RAINIERSHADE

NEW Recessed Funnel Cap – Feb 1, 2018

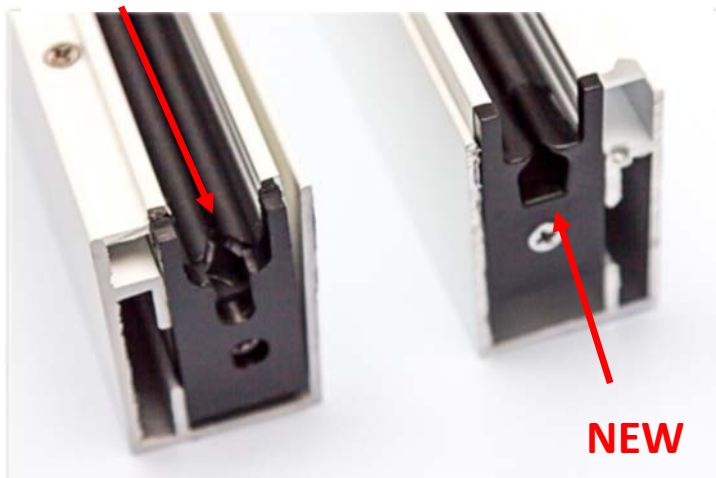
At Rainier Industries, we are constantly striving to improve our products. Over the last few years, we have received great feedback on the modified funnel cap for our surface track screens, so we have now applied that same feature to our recessed screens.

Starting on Feb 1, 2018, all new recessed screen shipments will feature the new funnel cap. This will allow the fabric to feed correctly every time and lead to a significant decrease in the number of service calls due to fabric misfeed after installation.

Note the consistency of the opening on the new molded piece, compared to the old hand-cut notch in the PVC insert.

New, clean, and better fitting pieces also on the bottom of the tracks.
